COA # 2011-COA-251(RP)	INDIANAPOLIS HISTORIC PRESERVATION COMMISSION STAFF REPORT	Hearing Date SEPT. 7, 2011
1010 Dr Martin Luther King Jr Street RANSOM PLACE		August 3, 2011
Applicant Meridith Hammer for Feroze and Sons LLC mailing address: 441 E. Ohio Street Indianapolis, IN 46204 <hr/> Owner: Anthony Fields 943 N California St Indianapolis, IN 46202		Center Township Council District: 9 Jackie Nytes
CASE		
IHPC COA: 2011-COA-251 (RP) <ul style="list-style-type: none"> • Construct commercial building • Install gas pumps and canopy structure • Signage • Landscaping and site improvements 		
STAFF RECOMMENDATION: Approval

STAFF COMMENTS

Below: New Site Plan

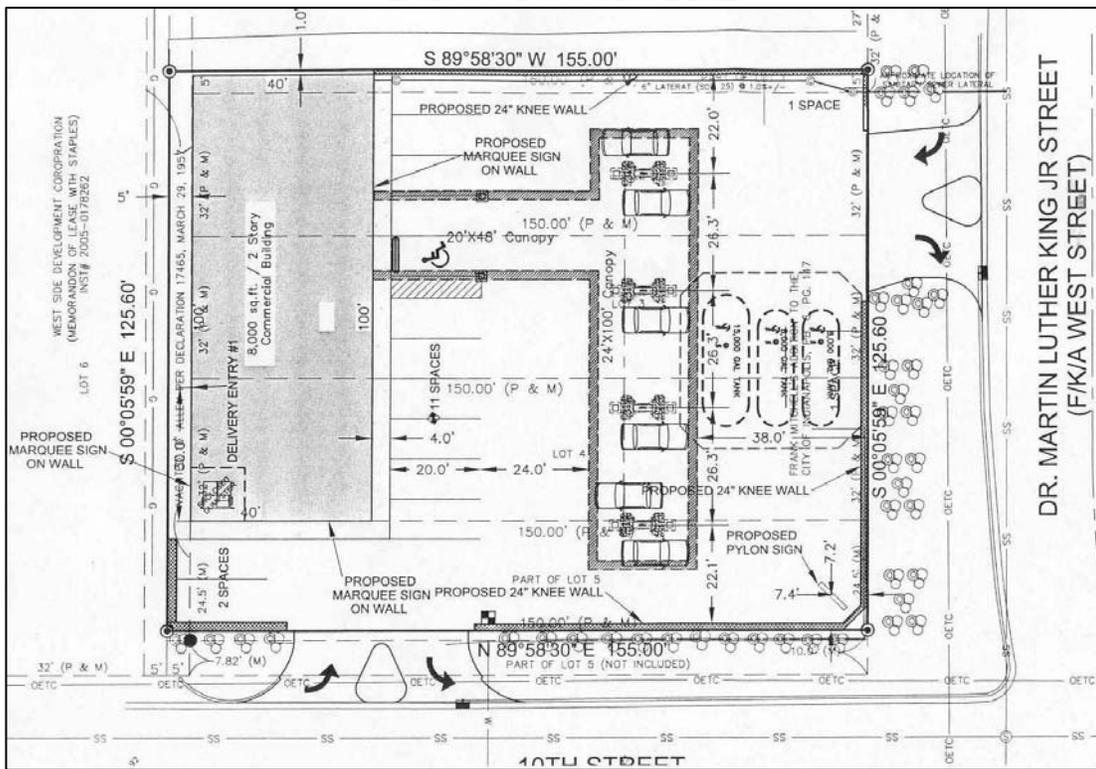
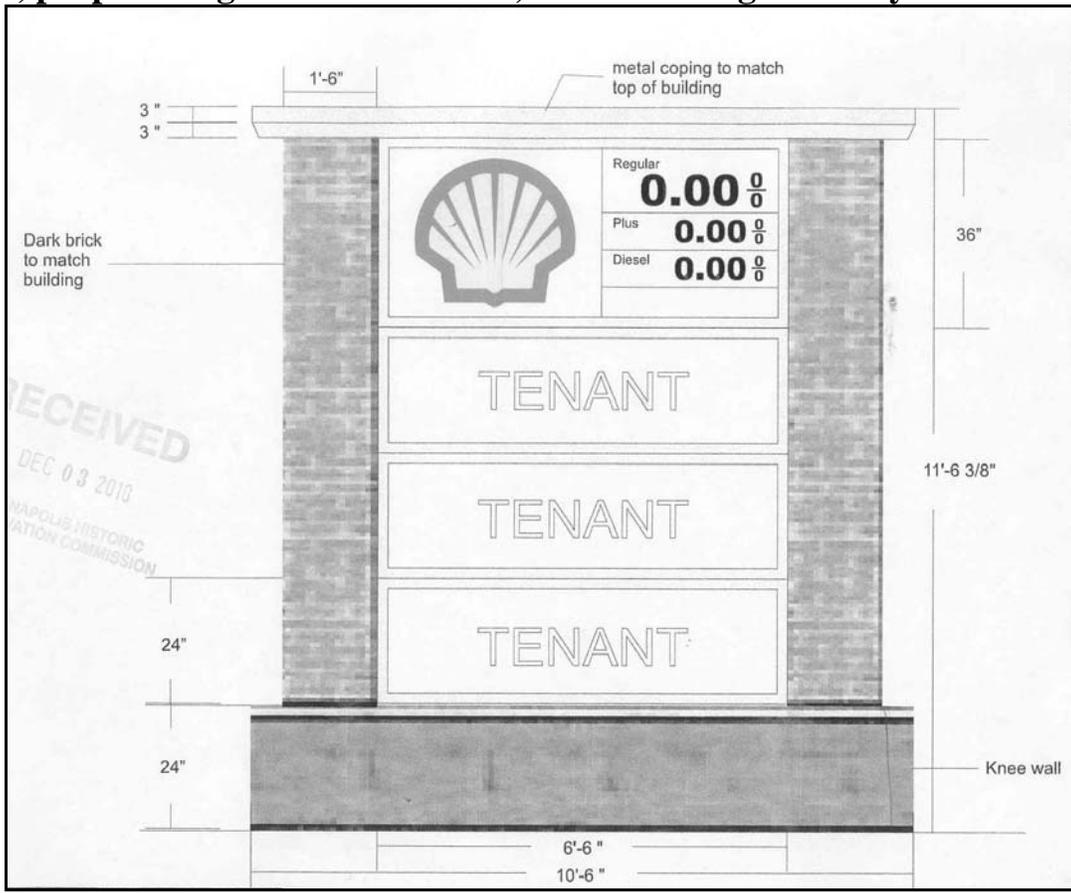
A median is proposed along Dr. Martin Luther King Jr St. to prevent northbound traffic from turning left into the site. The 10th St. entrance has been manipulated to avoid vehicles crossing each other when entering and exiting.

DPW offered comments on the previous site plan, and the applicant has addressed most of the comments with the newly proposed design in the following ways:

- The driveway on 10th St. appeared to send people driving into the building in the previous plans. Now that the building is much smaller, there is more space to enter the site.

- Traffic waiting to turn in may backup onto 10th St. This may still be a reality with this site no matter how it is designed. The applicant cannot make a prediction on this issue nor can they resolve it.
- The proposed median on Dr. MLK has been extended the length of the frontage along Dr. MLK in order to ensure people cannot make a northbound left turn or eastbound left turn at the cut.
- DPW recommended shifting the proposed median further to the east in order to prevent the southbound lanes from being only 10 ft. wide. This has also been changed on the plan.
